SERVICE LETTER 282

10000 Forward Strut Hardware Clearance

Aircraft Makes/Model(s):	Float Model(s):	Compliance: Optional	By: MAS
Air Tractor AT-802A, AT-802	10000A	Part Number: 1013203	Approved: DRH
		Date: 5/4/2026	Revision: A

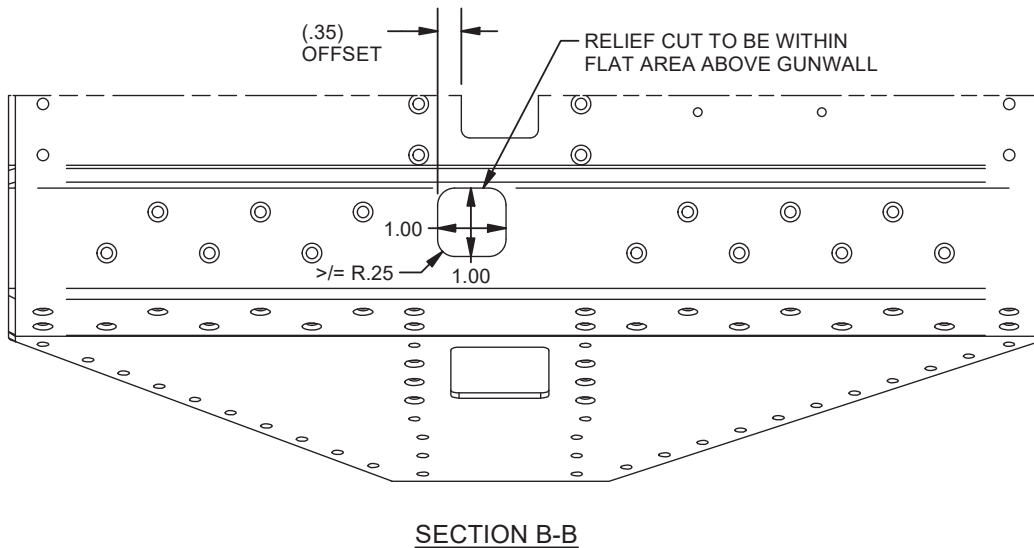
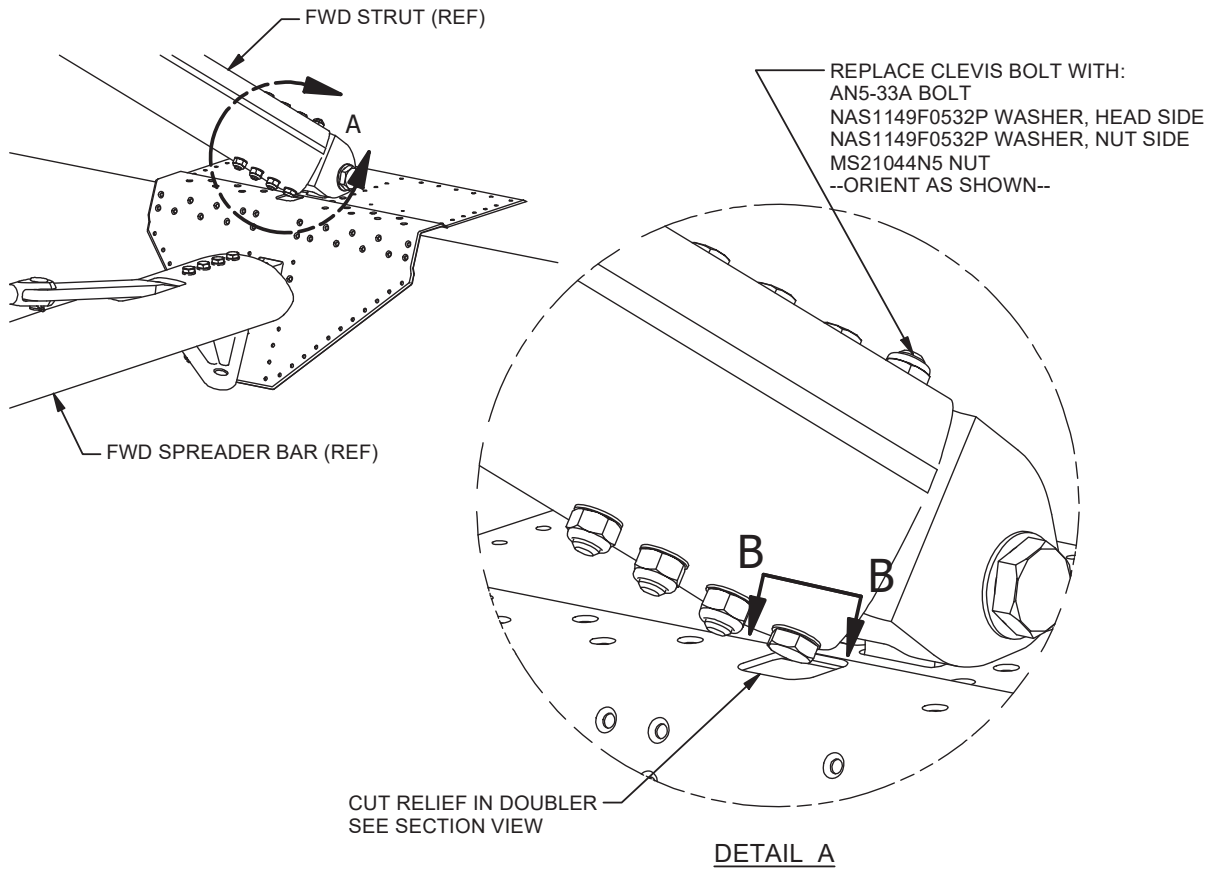
Forward strut attach point doublers – P/Ns 1011107 and 1011108 – were added to float structure to address smoking rivets at that location. Geometric limitations required a corresponding change to an adjacent strut fastener, becoming an AN25 clevis bolt. The limited space in the area and the orientation of the clevis bolt are such that strut removal is required if this bolt is to be replaced, and this procedure may not be feasible in forward operating areas. This service letter describes the option of cutting a relief into the doublers and exchanging the clevis bolt for an AN5 hex head bolt. This hex head bolt configuration with a washer under the head was in place prior to the addition of the doublers and is more appropriate for the curved surface of the strut.

12. Locate and cut relief holes into doublers. Holes to be 1" x 1" with corners radiused to at least R.25. A 1" circle is acceptable if this will provide adequate clearance. Refer to Figure 1.

13. Wet install doublers with PR-1422-B-2 sealant, or equivalent. Follow up with edge seal. Ensure coverage in the cut hole, as this area is prone to collecting water.

14. Install new strut hardware. Refer to Figure 1. Apply Tef-Gel (or equivalent) and torque to 48-68 in-lbs (60-85 in-lbs dry torque).
15. Reinstall spreader bar and struts and tighten flywires. Refer to Wipaire Install Drawing 7D1-4256, torque hardware per 14.3 and 16.4 of associated Wipaire Service Manual.
